UNITED STATES PATENT AND TRADEMARK OFFICE

Office Action Summary	Application No. 10/811,102	Applicant(s) WEIGERT ET AL.	
	Examiner Omar Rojas	Art Unit 2874

DETAILED ACTION

FIG. 1

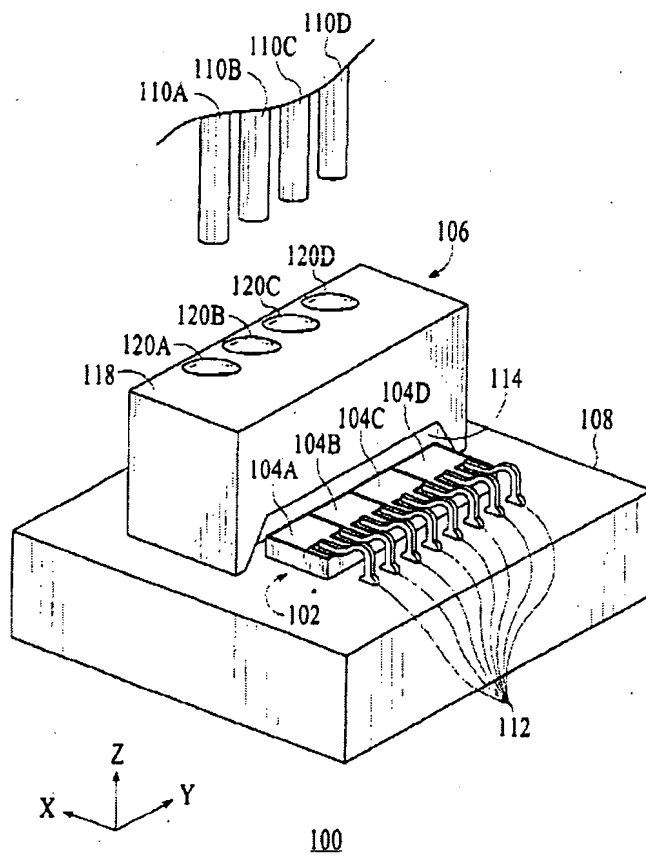
In re claims 1, 4, 8, 13, 14, 27, and 29, Wilson discloses an electrooptical module (100), comprising:

at least two electrooptical components (104A-104D) supported by a top surface of a common carrier (108) and operably coupled to an one optical waveguide (110A-110D), wherein:

the optical waveguide (110A-110D) is disposed above the top surface of the carrier (108);

the at least two electrooptical components (104A-104D) each are in an optical free-beam connection with the optical waveguide (110A-110D) by means of at least one lens (120A-120D);

an optical axis of emergent light from each of the least one lens (120A-120D) may converge so as to intersect an end of the optical waveguide at about the same point (column 4, lines 15-17);

wherein the electrooptical module (100) inherently comprises a WDM module because it has the same physical structure to that claimed;

wherein the at least two electrooptical components (104A-104D) comprises edge-emitting lasers arranged in a row (column 2, lines 60-62), the electro optical module (100) further comprising a supporting element (106) that has reflective coating (116, shown in Fig. 2) assigned to the laser or the lasers, the supporting element (106) and the reflectively coating (116) being arranged in such a way that they reflect the light emitted by the laser or by the lasers (104A-104D) about 90 degrees onto the respectively assigned lens (column 3; lines 29-36).

In re claim 2, the use of an "optical squint angle" for the lenses (120A-120D) is clearly suggested in Wilson's disclosure at column 4, lines 15-20 in view of Fig. 3. Furthermore, the waveguides (110A-110D) are arranged perpendicular to the top surface of carrier (108) as seen in Fig. 1.

In re claim 5, the lenses (120A-120D) are arranged on the supporting element (106) and located spatially above the electrooptical components (104A-104D) as seen in Fig. 1.

reproduced below. Additional labeling has been provided to Figure 1 of Trezza to more clearly show the claimed features.

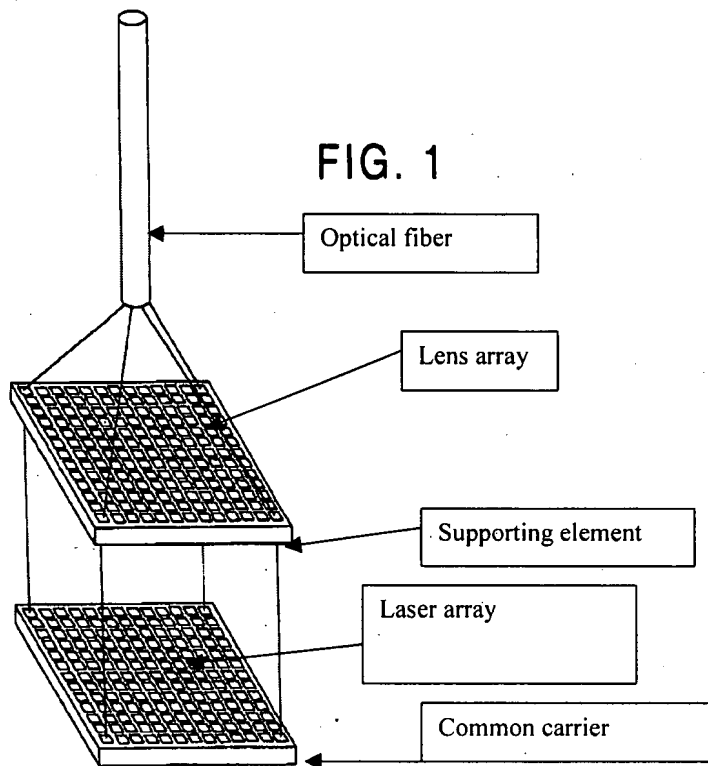
In re claims 1 and 8, Trezza discloses an electrooptical module (e.g., Figures 1-3), comprising:

at least two lasers supported by a common carrier and operably coupled to at least one optical fiber, wherein the optical fiber is disposed above the carrier;

the at least two lasers are in an optical free-beam connection with the optical fiber by means of at least one lens;

all the light from each of the lenses intersects the optical fiber at about the same point;
and

wherein the electrooptical module of Trezza inherently comprises a WDM module because it has the same physical structure to that claimed. A modified Figure 1 of Trezza is

In re claims 2-5, 11-13, and 25, the recited limitations are clearly apparent from Trezza's disclosure at column 1, line 42 to column 2, line 21 in view of the modified Fig. 1 shown above.
